Product Change Notification

Change Notification #: 119782-00

Change Title: Intel® Server System R1208WFQZSR, PCN 119782-00, Label, Product Material, Label update and adding alternate Hot Swap Backplane source

Date of Publication: December 07, 2023

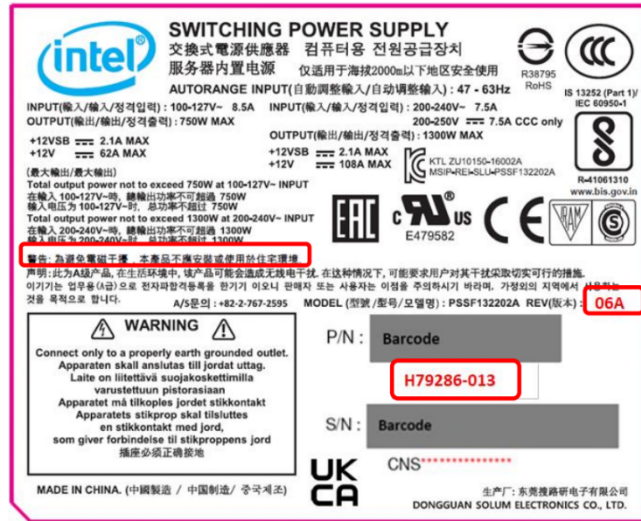
1. Addition of updated AXX1300TCRPS 1300W Power supply to the R1208WFQZSR SKU. The AXX1300TCRPS 1300W Power supply is changing from H79286-012 to H79286-013 due to a label update to incorporate the new Taiwan BSMI standards CNS15936 (CISPR32) and CNS15598-1 (IEC62368-1). The new BSMI standard has updated warning text that goes into effect January 1, 2024. Additional changes include a PSU firmware upgrade from 29.5.128 to 30.5.128 and a revision change from 05A to 06A. There is no impact to functionality.

Label-Before

Label-After

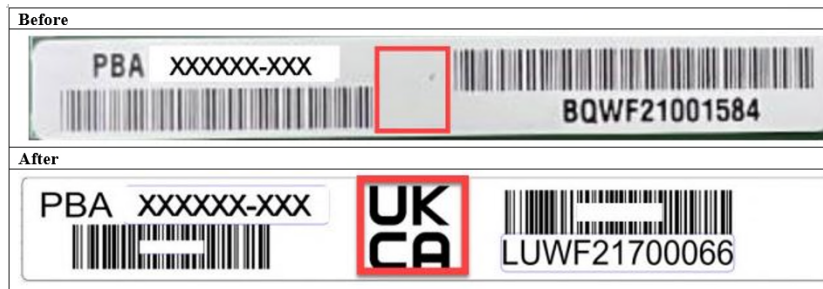
2. Adding the UKCA logo to the Server Mother Board Serial Number Label

Mother Board PBA Revisions are updated from M71674-951, M71674-951, H87178-951, H87178-961 to M71674-952, M71674-952, H87178-952, H87178-962
